Design Exception #6

Slopes for the Recreational Trail

**I-70 West Vail Pass Safety and
Operations Improvements**

Issue Task Force Design Exceptions Meeting #6

Recreation Trail Design Exceptions

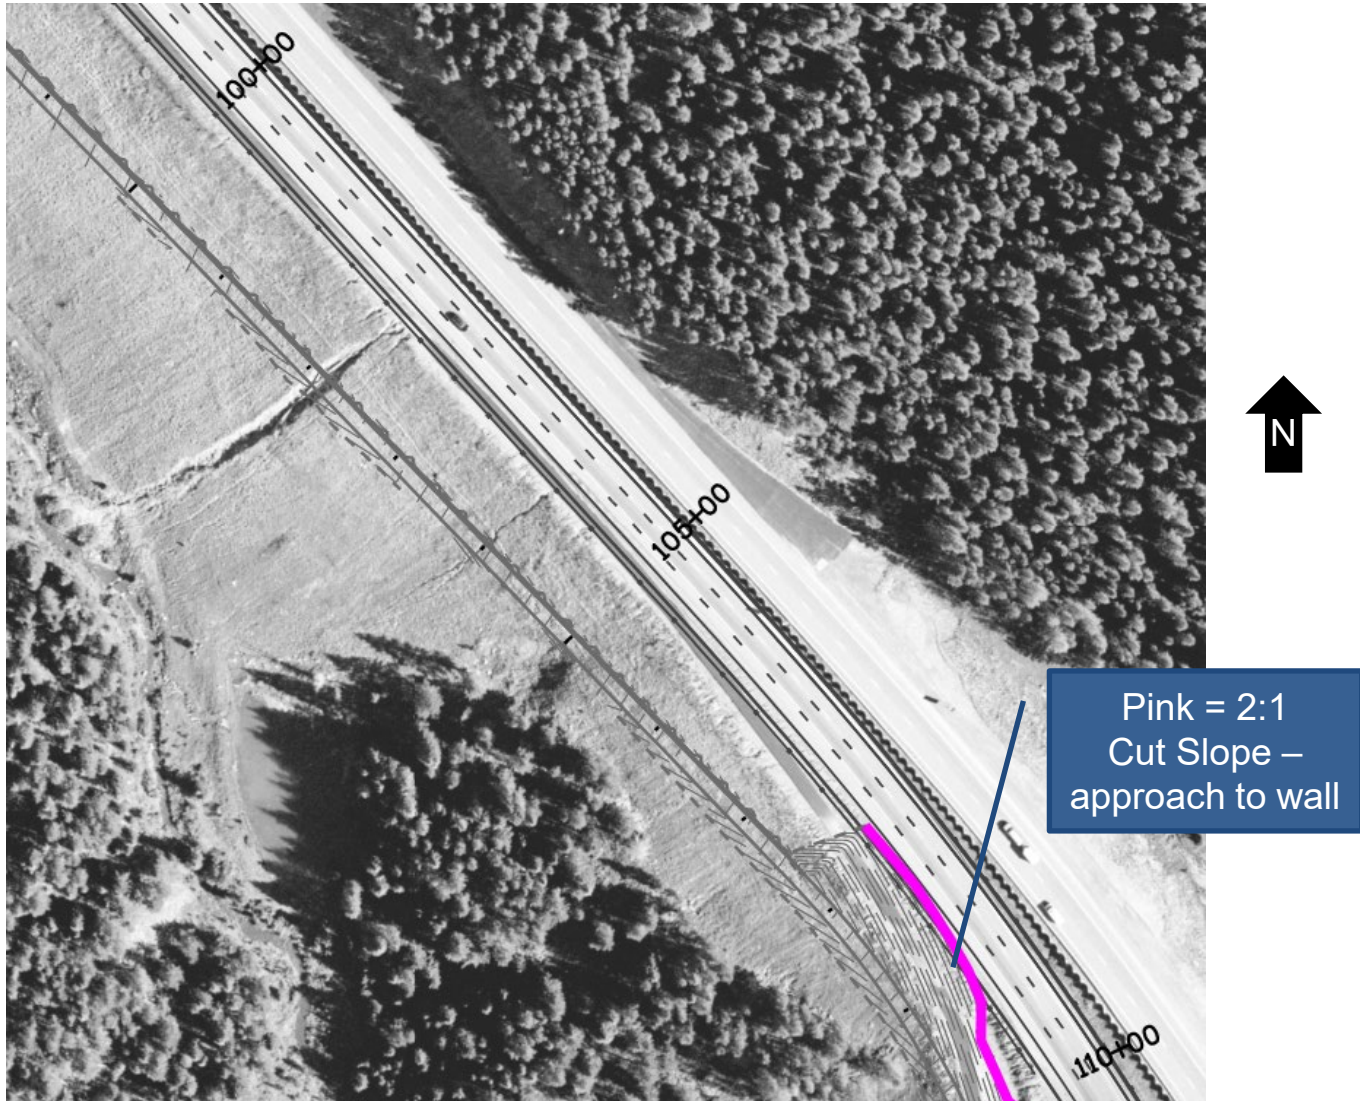
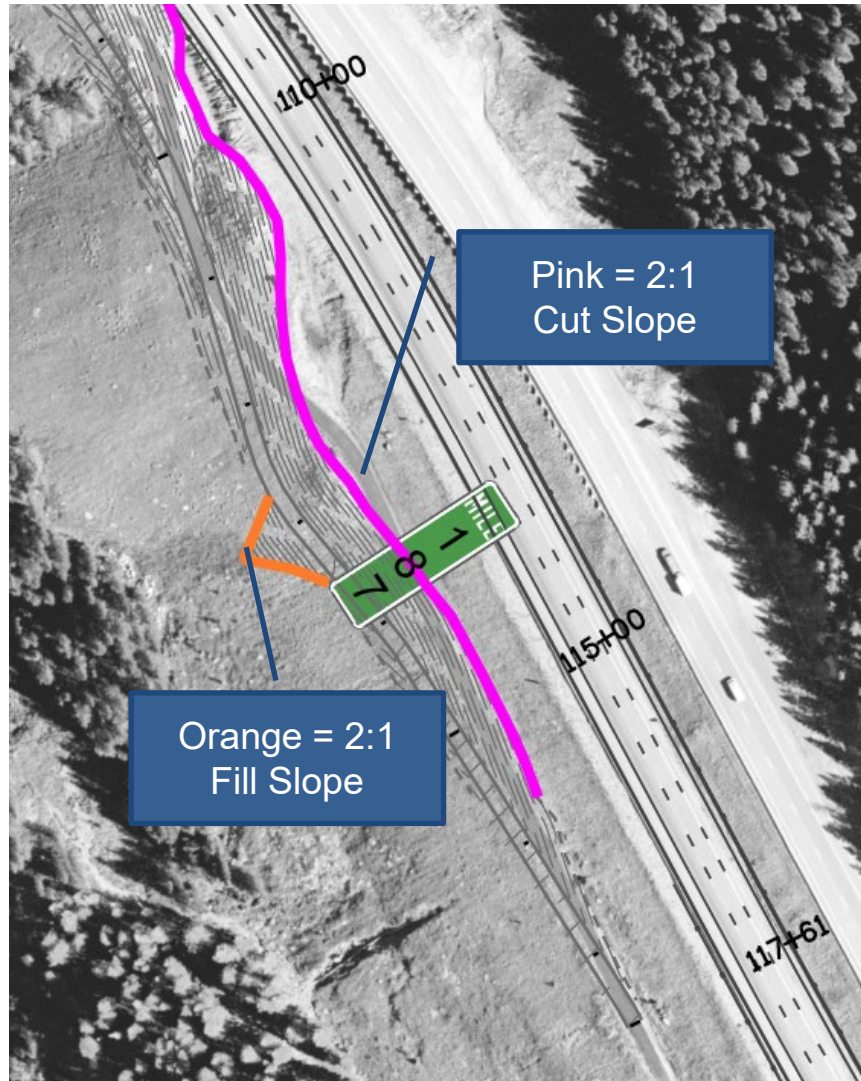
- Approximately 30% of the proposed slopes are 2:1
- Eliminating the 2:1 slopes creates more retaining walls, almost double
- Current 2:1 slopes are primarily approaching walls/ bridges or between the path and I-70

- a) Candice said one of the challenges with the recreation trail is the existing slopes are steep at 2:1. What we found in a quick analyses is that almost 30% of our proposed slopes are 2:1 instead of the preferred 2.5:1. If we don't use a 2:1 slope in the design, our retaining walls almost double. Using 2:1 slopes help keep the cost down quite a bit for the retaining walls. Obviously the walls have the least environmental footprint, but they cost more.

- i) Candice said you might be thinking, why don't you just bring the profile up to eliminate that? We've thought a lot about it ourselves but because of the overall elevation gain from the starting point to the ending point we have some very steep profile grades. We are trying to navigate the existing steep slopes with proposed slopes with retaining walls. Generally, those 2:1 slopes are approaching the retaining walls or bridges. That is where we are proposing to use the 2:1 slopes.

- ii) During our field visit we learned a lot and we will continue to evolve the alignment. In the area approaching Bridge 1 we looked at shifting the alignment a little further down the slope and that allowed some of these 2:1 slopes to be eliminated.

- iii) We've got some cut walls going down towards the creek and others approaching the bridge. Some of the bridge grading will be refined once we get the bridge abutment set and know what the grading all around the abutment and wing walls look like.

- iv) There are also some cut walls between the rec path and I-70 and the 2:1 slope Design Exception allows a slope instead of a retaining wall with some cut instead of walls the entire length. This is another area we looked at in the field that we might be adjusting based on the existing topography.

- v) Candice said there is a long cut wall where we won't have 2:1 slopes. We're just trying to tie into existing hillside and minimize the height of the cut wall.

- vi) 2:1 slopes will be used to stay further away from the highway in some locations. We will use an offset barrier in some locations to make sure we tie in at the barrier locations. The proposed slopes will be used to try to catch the tie in points where we have steep grades.

- i) Greg said the existing slopes from the interstate down, irrigation could be put in to really establish revegetation on the steeper slopes. He has a project that is putting in a lot of temporary irrigation. It seems with summers getting warmer, we can get vegetation to re-establish better on steep slopes with irrigation.

- ii) Greg said that's the hard part when you go to 2:1. You're kind of in a catch 22 situation. You use a steeper slope and put the protection on there but if your seeding doesn't take, it's really hard to reseed it a second time to get it to take. That would be my concern about these design exceptions.

Use slopes ranging from 2.5:1 to 1.8:1 as directed by the project Landscape Architect to create a slope that fits into the adjacent landform, looks natural, sustains vegetation and is maintainable.

Hearing no objections or language change suggestions, Mary Jo said we will move forward with the assumption that everyone is comfortable with these slope design exceptions and with the PLT approval, our designers will move forward using this design exception.

Recreation Trail Design Exceptions

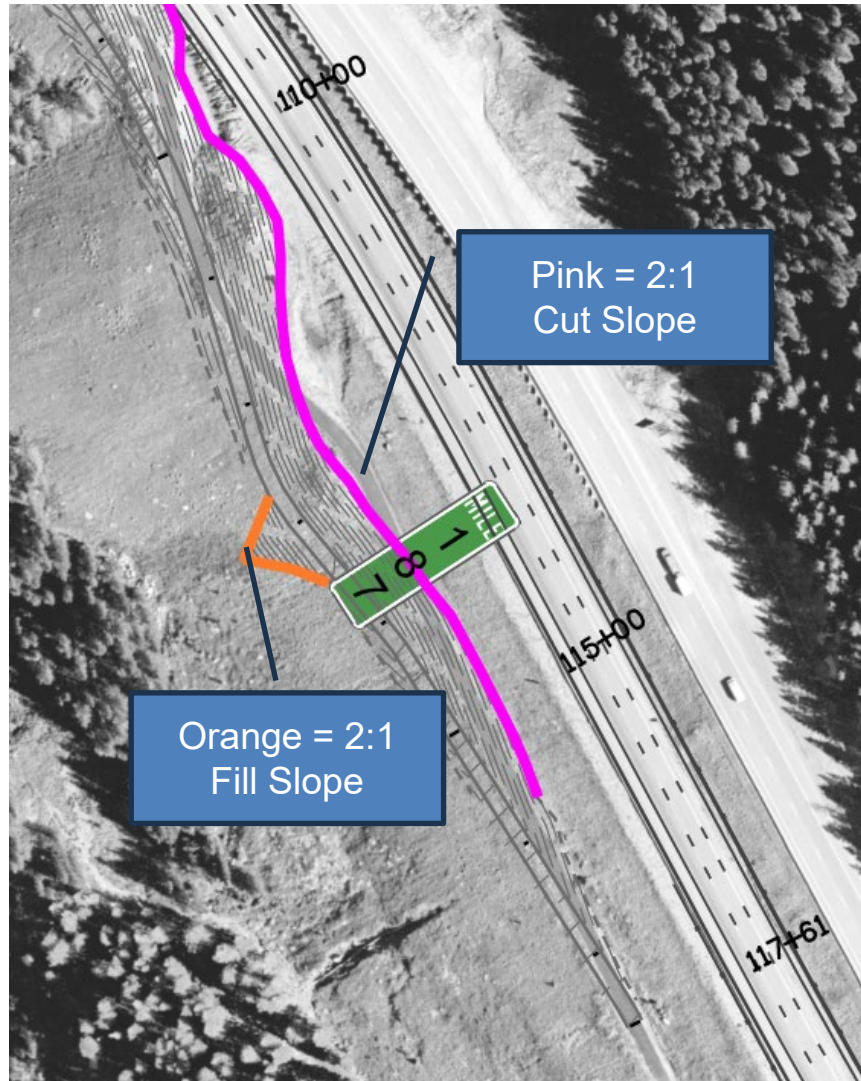
- Approximately 30% of the proposed slopes are 2:1
- Eliminating the 2:1 slopes creates more retaining walls, almost double
- Current 2:1 slopes are primarily approaching walls/ bridges or between the path and I-70

The recreation trail currently has about 12 locations where they don't meet the slope requirements. The number could increase as the trail design continues to have fewer conflicts with wetlands and trees. About 30% of the slopes being proposed will be at 2.1 along the recreation trail. If we go to 2.5:1, we are going to create almost twice as many walls. We are primarily doing these at approaches to bridges or between the trail and I-70. You can imagine as we get closer to I-70, it is harder and harder to keep a more shallow slope of 2.5:1.

If you had the slope at 2.5:1, it comes further and further out just to meet the existing grade, so you create more and more disturbance area. Not only does it come out further, but it also goes further along the trail.

- a) Dick asked in the areas where we have the steeper slopes, do you have to do additional sediment control or debris control or additional gutters along the trail to prevent debris on the trail.

John said on the previous slide it showed spray on mulch which we wouldn't use. We would use biodegradable erosion control blankets so we would have that extra measure to help the grass grow on the steeper slopes and we have had great success in getting the grass to grow there.

In this case, where we have the 2.1 there are little rills that form on the steep slopes just because of the runoff from I-70. Here we are making an effort with the new lane to capture that water and are going to manage the water from the road which then has an influence on the bike path. The bike path, in these areas with the steeper grades, is going to see less water that gets to the path now. We have some drainage features on the recreation trail so in areas where we are closer to I-70, we have taken steps to manage it much better than it is managed now

Randal said there is a ditch at the bottom and that will help avoid any sediment getting directly on the path and then we are looking at all the ways we can take the water that is running in those ditches and put it through some sediment containment pieces or run it through natural vegetation to diminish the sediment load.

Use slopes ranging from 2.5:1 to 1.8:1 as directed by the project Landscape Architect to create a slope that fits into the adjacent landform, looks natural, sustains vegetation and is maintainable.

The PLT had no objections to the process and approve the recommendation.
